NEWFOUNDLAND POWER
DAM SAFETY EVALUATION
LOCKSTON DEVELOPMENT

NEWFOUNDLAND POWER
DAM SAFETY EVALUATION
LOCKSTON DEVELOPMENT

DECEMBER 31, 2000

Penstock Leakage & Drainage

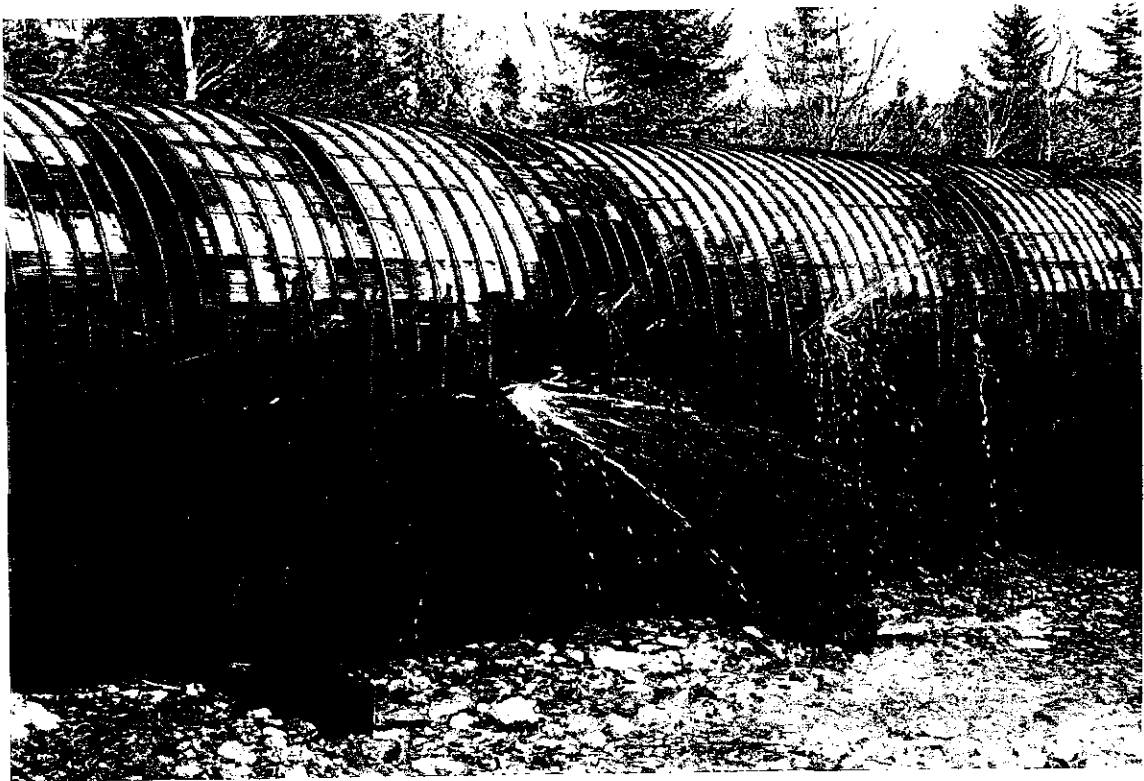
The penstock is a wood stave pipeline on wood cradles and sills. The penstock is in poor condition with significant leaks throughout the full length. The extent of flow from the leakage has caused the bedding to be washed away and cradle supports eroded.

In attempt to repair the leakage, steel bands have been continuously tightened resulting in crushing of the wood staves. Steel bands were noted missing in at least two locations.

The penstock needs to be considered for total replacement. In the interim, direct leakage away from the penstock supports.
